Flood Risk Assessment Addendum Rev1

117 – 119 Slack Road,
Manchester,
M9 8AZ

23 November 2021

Figure 1 - EA LiDAR Data

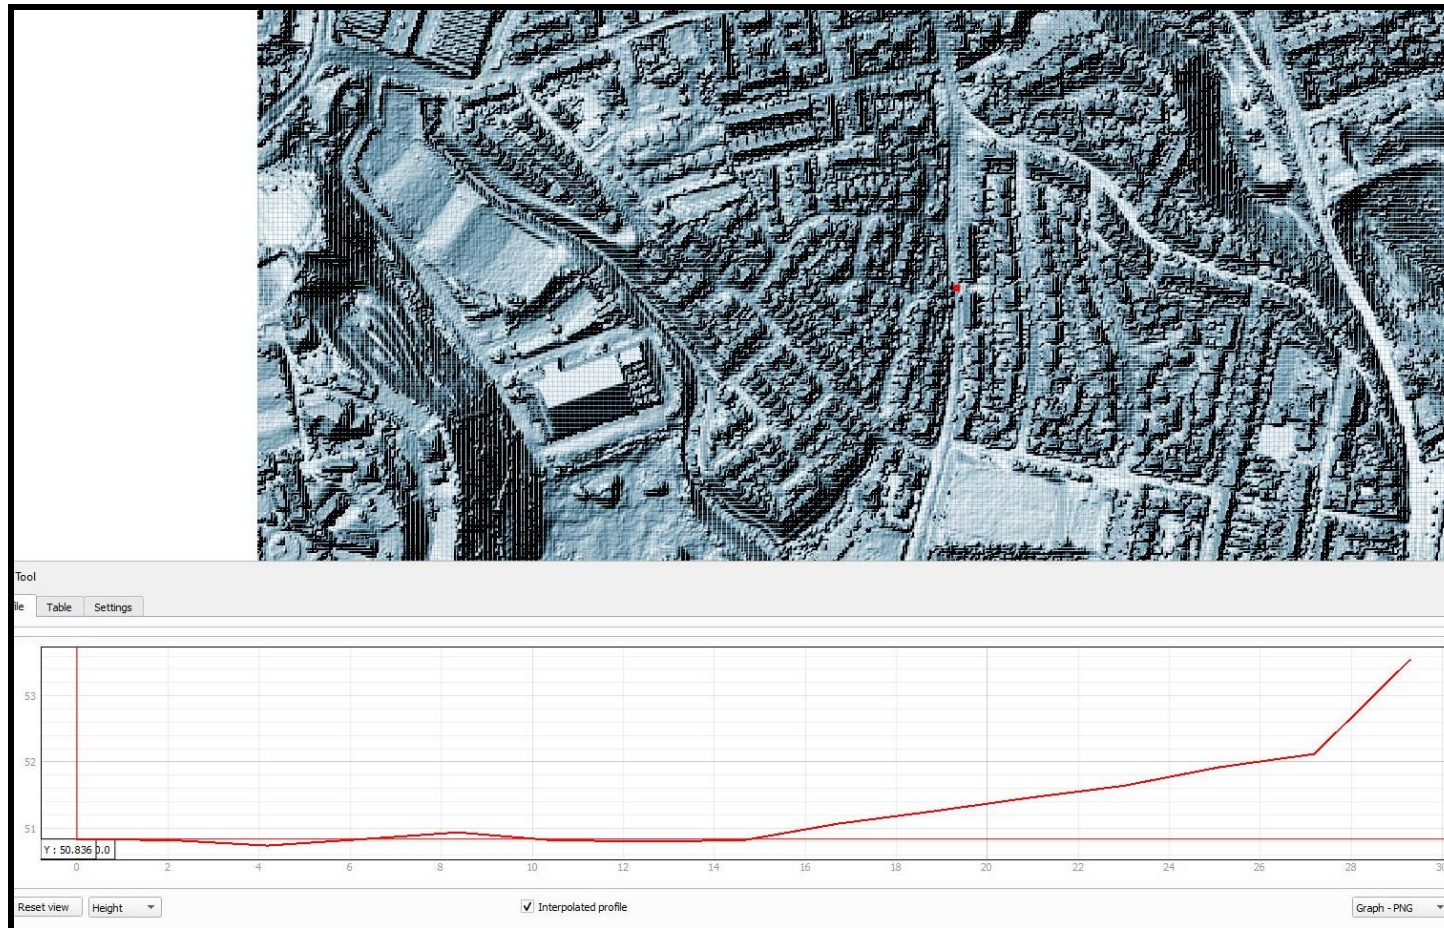
- While the additional information does provide some clarification to my [below] points, I would need to see the FRA updated to include the updated information and reassess the level of flood risk posed to the new development.*
- In addition, I would also like to see an assessment of raising the finished floor levels 300mm above the 1 in 100 year flood event (including climate change if possible, and if this is not possible flood resistant building techniques and materials should be considered) as per the standing national advice.*

- 1 in 100 year plus 70% CC – 51.27m AOD
 - 1 in 1000 year – 51.25m AOD
- LiDAR data has been obtained from the EA (see **Figure 1** overleaf) and a desktop study of the site levels has been undertaken by KCS Ltd.

- The road level at the entrance to the site is 50.83m AOD
- On this basis, (and recognising that the road level is lower than existing site levels) potential depths of flooding would range from 240mm in the 1 in 100 year event, rising to 360mm in the 1 in 100 year plus 35% allowance for climate change and 440mm in the 1 in 1 in 100 year plus 75% allowance for climate change.

Figure 2 - Possible Flood Displacement Routes

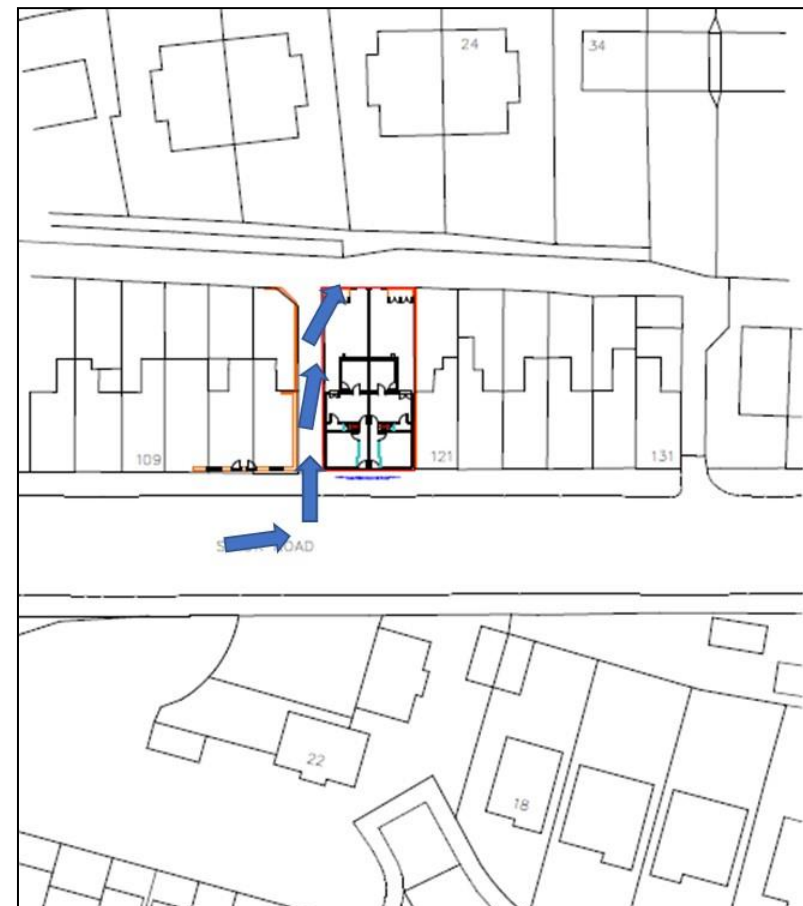
- 3. The FRA should assess the risk of the development displacing flood water and how this will impact on surrounding properties.*
- 4. The FRA should include an evacuation plan identifying safe access and egress routes. We would also encourage that the properties are registered with the EA to receive early warnings of flood events*

It is important to note that, immediately to the north of the portion of land proposed for development, is a footpath. This, and the rear of the site (and the rear of the adjacent properties) are shown to be in Flood Zone 1 (see **Figure 3** overleaf)

Should any floodwaters be displaced by the development, the floodwaters could flow down the footpath towards the rear of the proposed site.

Figure 3 - Access and Egress Route

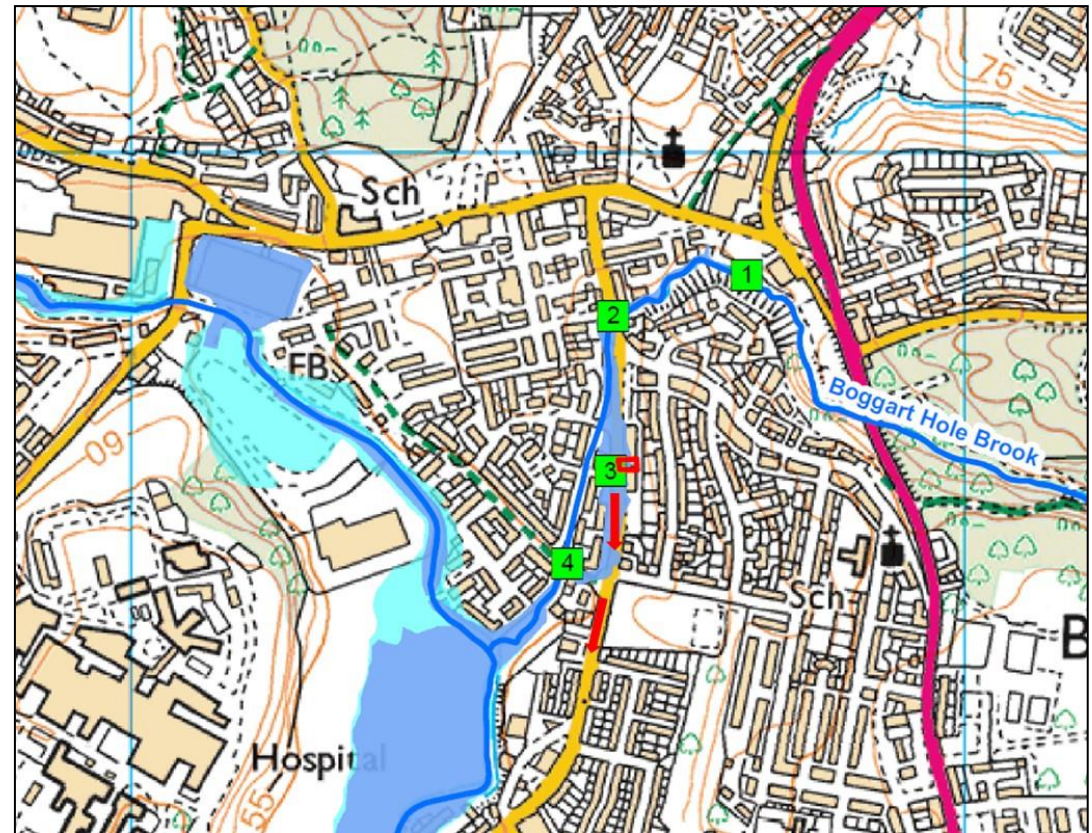
The FRA should include an evacuation plan identifying safe access and egress routes. We would also encourage that the properties are registered with the EA to receive early warnings of flood events

This safe route is based on the fluvial flood outlines and surface water flooding risk. In this instance, it would appear that leaving the property and travelling down Slack Road in a southerly direction (away from where Boggart Hole Brook crosses Slack Road) would be the best option.

Appendix C - Section Plan (prepared by KCS Ltd)

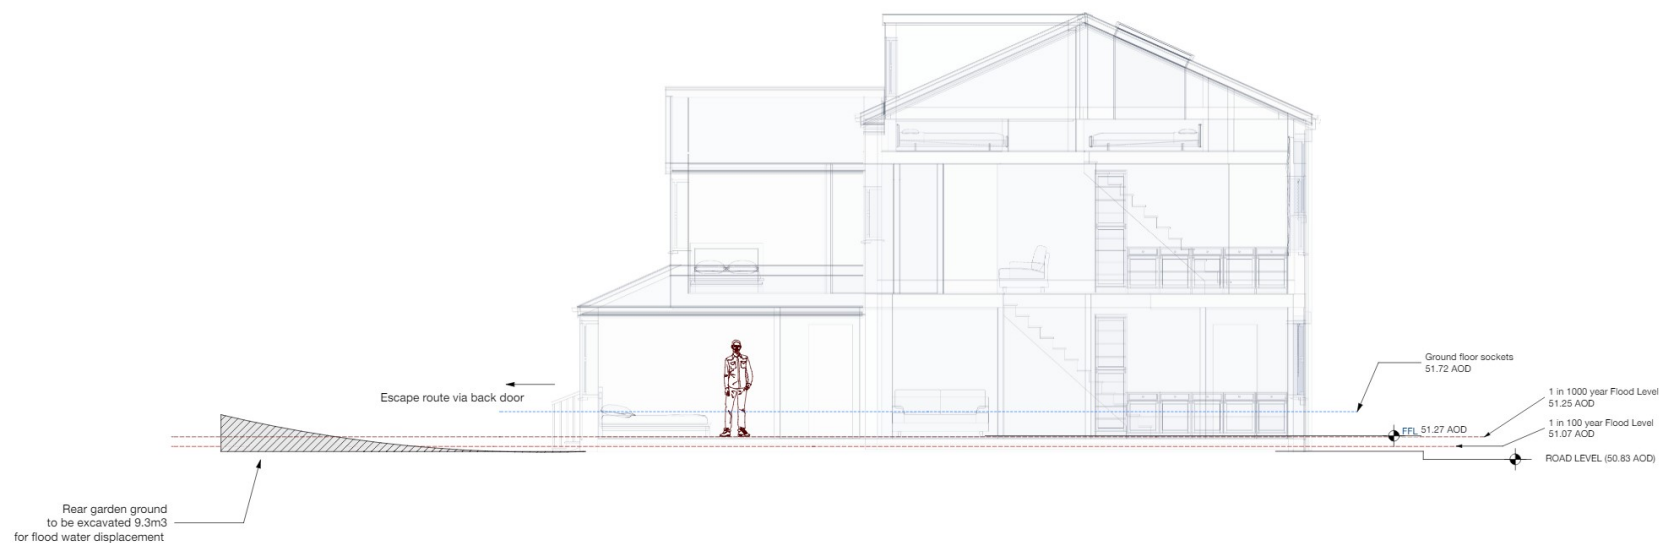
-
- *I would also note that I would like to see an update of the excavation calculations (following confirmation of existing site levels) to avoid flood water displacement from the proposed property, this should again be discussed within the FRA.*

- A Section Plan has been provided by KCS Ltd. A copy of this is provided in **Appendix C** of this Addendum.
- As shown on the plan, finished floor levels are to be set at 51.27m AOD, which is the 1 in 100 year plus 75% allowance for climate change level and provides a 200mm freeboard above the 1 in 100 year modelled flood level.

- Compensatory storage will be provided at the rear of the property which is located outside of the flood extents; the land will be lowered to provide 9.3m³ of flood compensation. Channels will be provided to direct any flows to this lowered area of land.
- KCS Ltd calculated the volume of land from the elevation rise measured onsite which agrees with the lidar elevation data.
- The rear garden rises steeply towards the rear. Therefore, as part of the landscaping this portion of site will be levelled with the house.
- The Section Plan provided in **Appendix C** shows the location of the compensatory storage.
